# Technical Service Bulletin

<b>Subject:</b> <b>DRIVER SEAT CUSHION SURFACE WARPING - (LEATHER SEATS ONLY)</b>	<b>Bulletin No.:</b> 09-020/19
	<b>Last Issued:</b> 04/30/2019

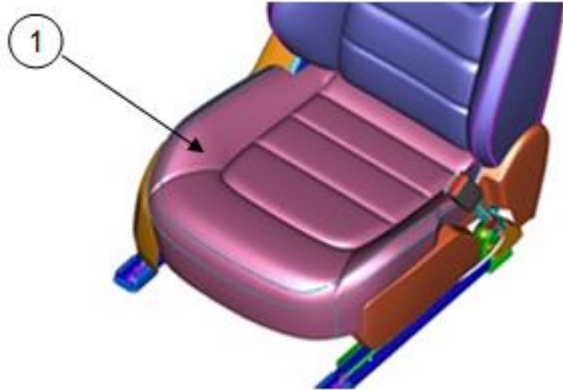
Some customer may complain of warping on the driver seat cushion trim, which may cause poor appearance complaints. This is caused by a gap between the leather seat surface and the seat cushion pad due to insufficient tension on the seat trim. To eliminate this concern, a non-woven fabric has been attached to the backside of the seat trim to increase tension.

1. Verify the customer complaint.
2. Replace the front seat cushion trim (1) and the front seat cushion pad with a modified parts according to the instructions on MGSS online (FRONT SEAT CUSHION TRIM REMOVAL/INSTALLATION).

**NOTE:** It is not necessary to completely remove the side seat covers. Loosen the front of the covers only (as shown below) to access the side of the seat cushion.

**CAUTION:** Be careful not to break the side covers.
